State of Utah  
DEPARTMENT OF NATURAL RESOURCES  
DIVISION OF OIL, GAS AND MINING

August 22, 1995

RE: Alternate Sediment Control Amendment, Trail Mountain Mine, PacifiCorp Electric Operations, (ACT/015/009-95G, Folder #3, Emery County, Utah)

The amendment updates the alternated sediment control designs (ASCD's), Plate 7-11 shows eight different typical designs. Such sediment control measures provide primary control in specific approved disturbed areas and redundant control in other areas.

PLATE 7-11

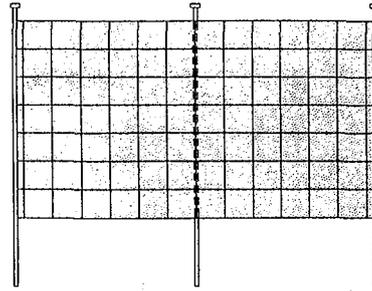
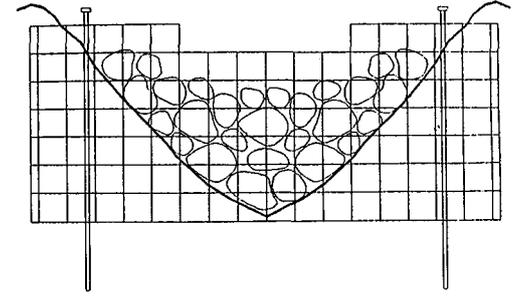
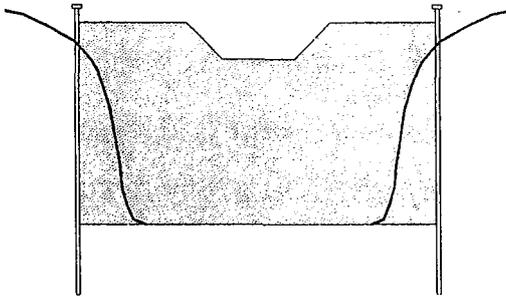
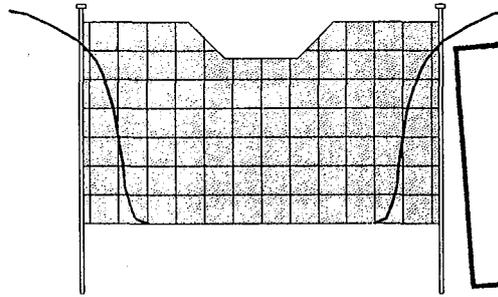
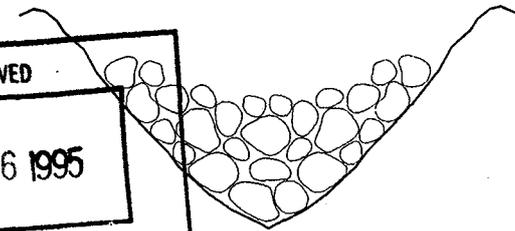
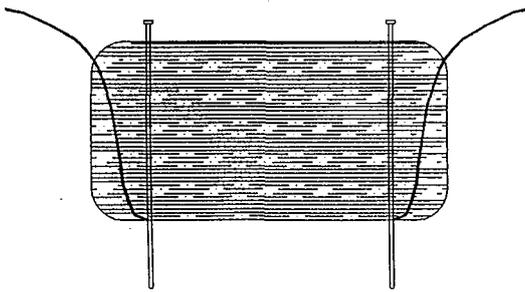
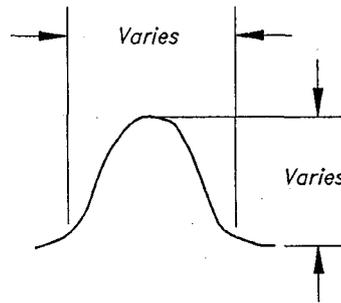
- (1) The applicant submitted a complete and accurate amendment application.
- (2) DOGM PERMIT STATUS. The ASCD's are approved environmental control measures utilizing the best technology current available and lie within the permit area (R645-301-742.110).

- (3) ACTIVE MINE. The ASCD's currently are in place within the disturbed area and are shown on map as required by DOGM Directive-Tech-003A dated June 7, 1995.
- (4) LAND STATUS. Not applicable.
- (5) OTHER APPROVAL. Not applicable.
- (6) IMPACTS. Not applicable.
- (7) RECLAMATION AND BONDING. Not applicable.
- (8) RECORD UPDATE. The MRP documents updated by this approval are as follows:
